Technical Information

911 GT3 Cup (997)

Drive shaft

Bild 1: Aufkleber auf Schaft der Gelenkwelle zur Bauteil-Identifizierung

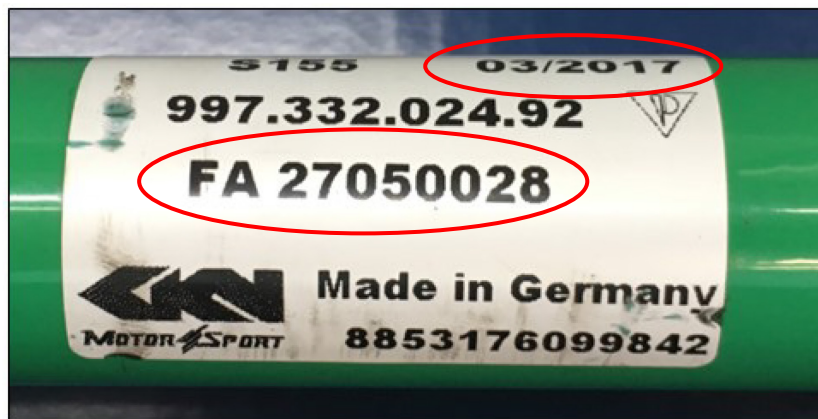
Zur Identifizierung der betroffenen Bauteile muss die Chargen-Nr. und das Fertigungsdatum auf dem Aufkleber der Gelenkwelle abgelesen werden:

Picture 1: Sticker on drive shaft for part identification

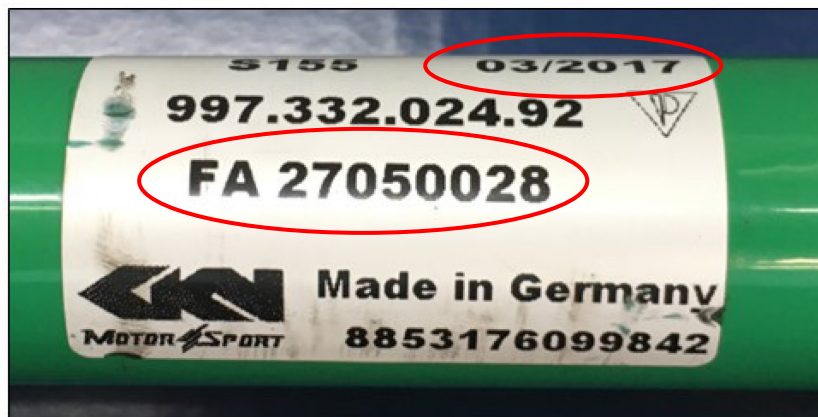
To identify the affected parts the batch & production number is visible on the label attached to the driveshaft.
